**Public Works Committee**  
**Monday, September 9, 2024**  
**9:00am**  
**18 Oxford Place, Madison WI**  
**In-Person or Online/Via Phone**

Subject: Planner Review of Building Board Application for 1155 Farwell

**The DAVIES Residence**  
 1155 Farwell Dr  
 Madison, Wisconsin

**GRADING & EROSION CONTROL PLAN**

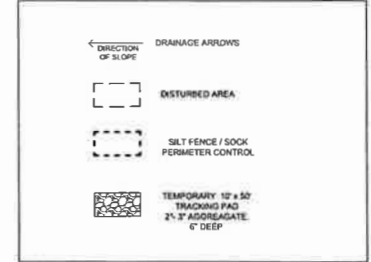
2. Infrastructure Impact Review:
  - a. Property includes a 20' sanitary sewer easement generally perpendicular to the side lot lines in the rear yard. In this easement, the plans suggest removal of an existing walk, installation of new landscaping, but no proposed hardscaping aside for a handful of flagstone step stones. As a condition of approval, I recommend that, prior to the commencement of any work, the construction crew meet with the Village Director of Public Works to have the sanitary sewer line marked and identify protection strategies to assure the protection of that line, periodic inspection, and proper restoration. This conversation should also involve site grading, erosion control, and seasonal pool drainage.

- f. § 192-22 E. requires a permit from the Public Works Committee before any excavation in the public street right-of-way, including restoration requirements. *The grading and erosion control plan indicates a 50' wide temporary gravel access driveway from Farwell Drive south of the permanent driveway, intended for movement of materials, plus an indication that daily clean-up of the roadway will occur. As a condition of approval, I recommend that, prior to the commencement of any work, the applicant secure the necessary permit via Village Director of Public Works and meet any requirements associated with that permit, including removal and restoration requirements.*

A motion was made by Renee Riviere and seconded by Jeff Olsen to approve the plans as presented. A friendly amendment was made by Renee Riviere, adding that the grading not change and the condition to de-conflict with the Public Works department in regard to the easement be added. Jeff Olsen is ok with the friendly amendment. Motion carried.
